Access Compliance Report

(Curb Ramps)

Intersection ID: 48195	Main Street: BLAKENEY CENTRE DR	Cross Street: REA RD	Location: SE
ADA ID: 7CCFBA4029E2	Ramp Type: PerpDiag	Initial Pass/Fail: Fail	Overall Compliance: No
Severity Score: 33.75			
Codes/Mitigation Info/Possible Solution		Field Measurements/Component Compliance

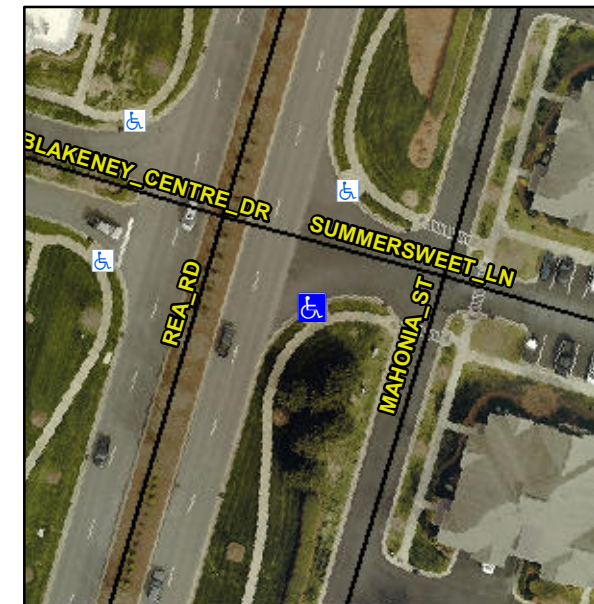
R304.5.1, R304.2.2

Compliance	Description	Data	Compliance	Description	Data
N/A	Ramp Length (in)	76.0	No	Ramp Slope (%)	13.6
No	Ramp Width (in)	42.0	Yes	Ramp XSlope (%)	1.4
N/A	Flare Type LT	N/A	N/A	Flare Type RT	N/A
N/A	Flare Slope LT (%)	N/A	N/A	Flare Slope RT (%)	N/A
N/A	Flare Traversable LT?	N/A	N/A	Flare Traversable RT?	N/A
N/A	Landing Length (in)	N/A	N/A	DWS Provided?	N/A
N/A	Landing Width (in)	N/A	N/A	DWS Contrast?	N/A
N/A	Landing Slope (%)	N/A	N/A	DWS Length (in)	N/A
N/A	Landing X Slope (%)	N/A	N/A	DWS Full Width?	N/A
N/A	Landing Curb? (Y/N)	N/A	N/A	DWS Offset (in)	N/A
N/A	Shared Landing?	N/A			
N/A	Gutter Ponding?	N/A	N/A	Gutter Slope (%)	N/A
N/A	Gutter Lip Ht (in)	N/A	N/A	Gutter X Slope (%)	N/A
N/A	Painted X Walk1?	No	N/A	Painted X Walk2?	No
	X Walk 1 Direction	To NE		X Walk 2 Direction	To NW
N/A	X Walk 1 Width (in)	N/A	N/A	X Walk 2 Width (in)	N/A
	X Walk 1 Slope (%)	1.9		X Walk 2 Slope (%)	4.0
	X Walk 1 X Slope (%)	2.8		X Walk 2 X Slope (%)	0.2

Remove & Replace Curb Ramp With Two New Directional Ramps or Equivalent.
